NUCLEAR ENERGY INSTITUTE

Subject: Summary of NEI/NRC Telecon on March 4, 2008

Project Number: 689

Notes on seismic hazard sensitivity studies for Eastern Tennessee Seismic Zone

Figure 2: EPRISOG sources used to represent ETSZ, plotted with historical earthquakes from the EPRISOG catalog (figure courtesy of WLA).

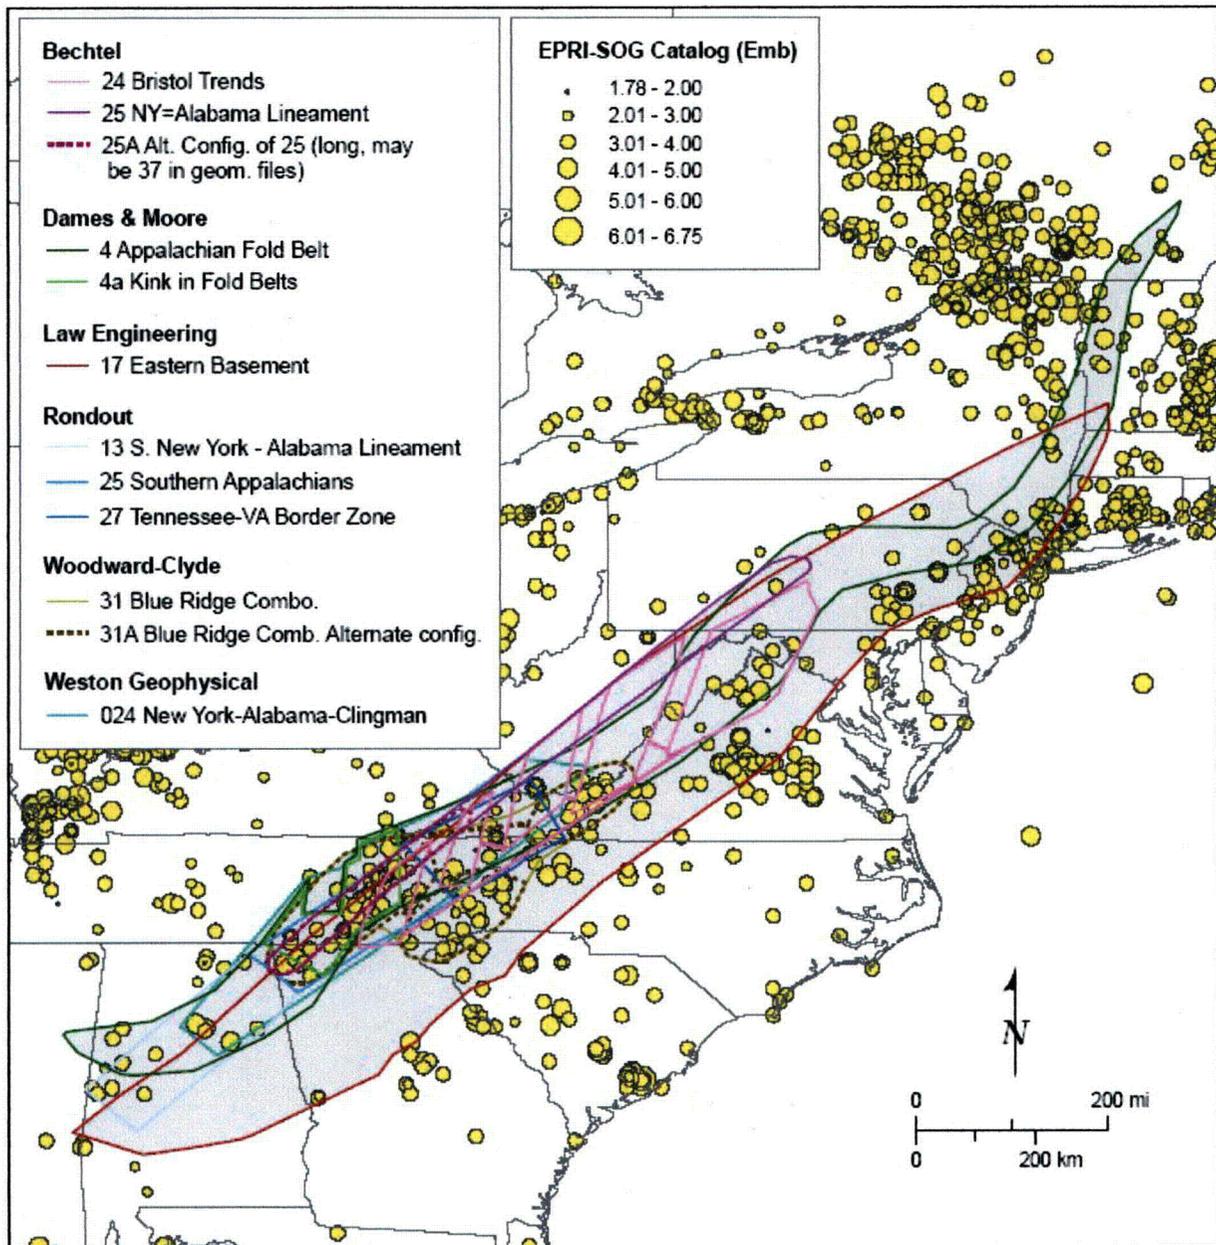
Cliff Munson/Rebecca Karas – NRC staff has reviewed the additional information provided on March 3 and agree with the sensitivity study approach which appears reasonable, but have a few questions:

1. Question that the Woodward-Clyde background source zone seems high
2. Would like to see the effects of individual sources, broken-out by each EST
3. Need coordinates (latitude/longitude) for each of the EPRI seismic sources used

4. Question the minimum magnitude evaluated and magnitude scale

1. The Woodward-Clyde background source zone is high, but this is their representation.
2. Individual sources can be broken-out by EST, and will be evaluated at 1Hz and 10 Hz.
3. Seismic source coordinates can be provided, but will need to be released by EPRI.
4. MB 3.3 was used as minimum magnitude (with EPRI screen at magnitude 3.0).
